TI_2508: Glass pane support

iCombi Pro 6-2/1 & 10-2/1, SelfCookingCenter 6-2/1 & 10-2/1

02/07/2025

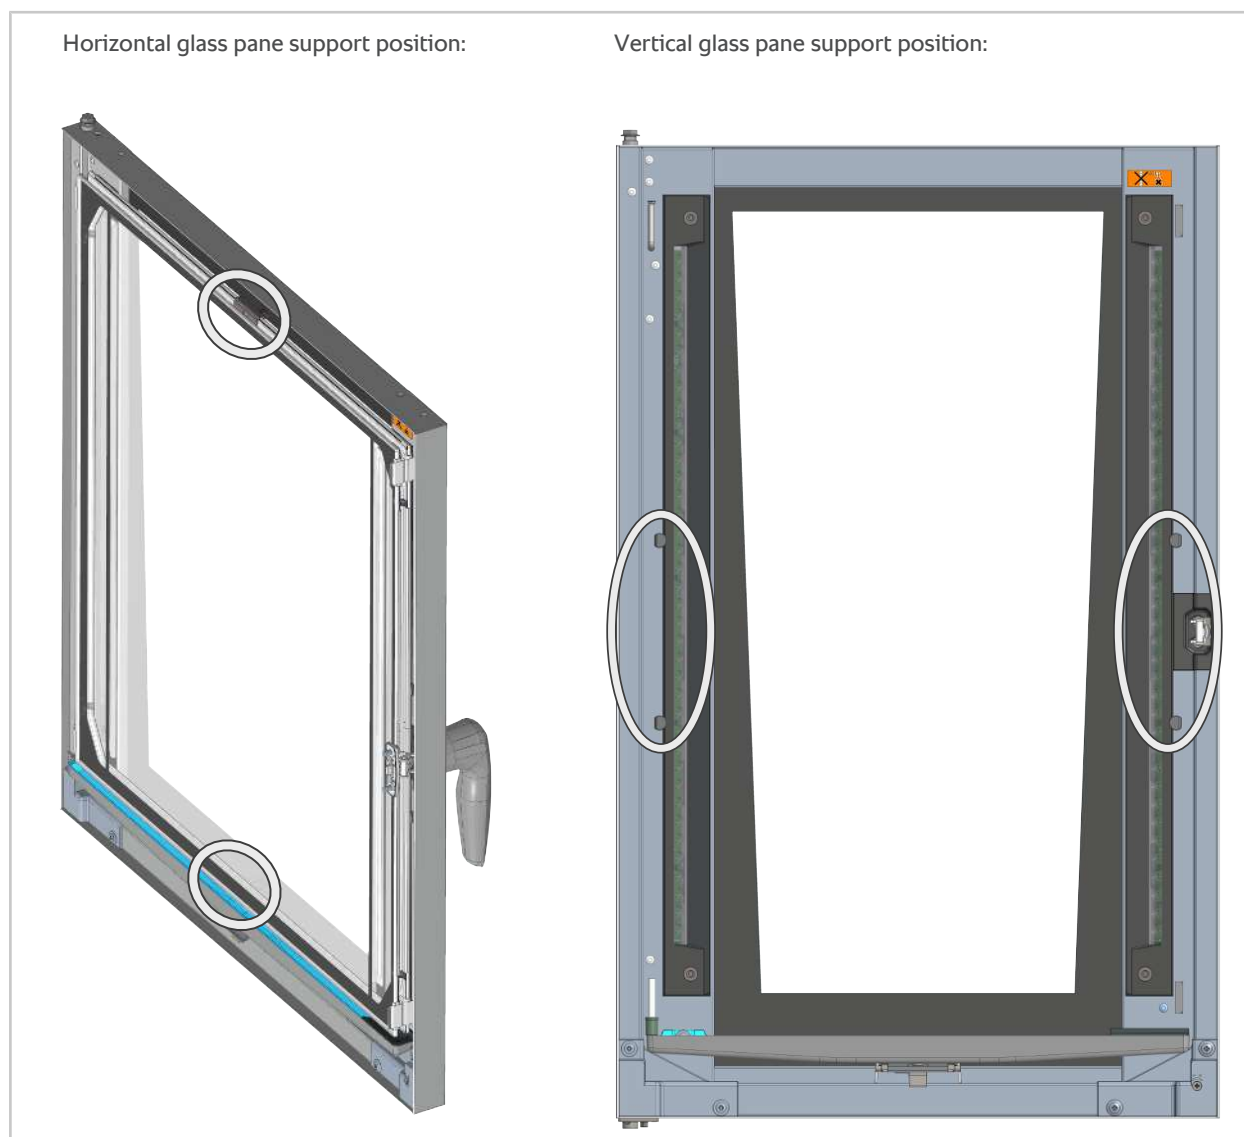
A glass pane support (1) has been developed in response to frequent feedback regarding pane corrosion and the associated pane deflection.

This support does **not** prevent glass pane corrosion. However, the support counteracts deflection when the glass pane package is closed.

The horizontal glass pane support will be installed from 05/2025 on the following units:

The vertical glass pane support will be installed from 05/2025 on the following units:

Notice: The glass pane supports cannot be retrofitted on older doors (before 05/2025) and older glass pane packages (before 05/2025).

- iCombi Pro/SelfCookingCenter 6-2/1:
- The glass pane package with item no.: 24.04.896 will be replaced from 05/2025 by the glass pane package with item no.: 24.06.269.
- iCombi Pro/SelfCookingCenter 10-2/1:
- The glass pane package with item no.: 24.04.898 will be replaced from 05/2025 by the glass pane package with item no.: 24.06.270 .
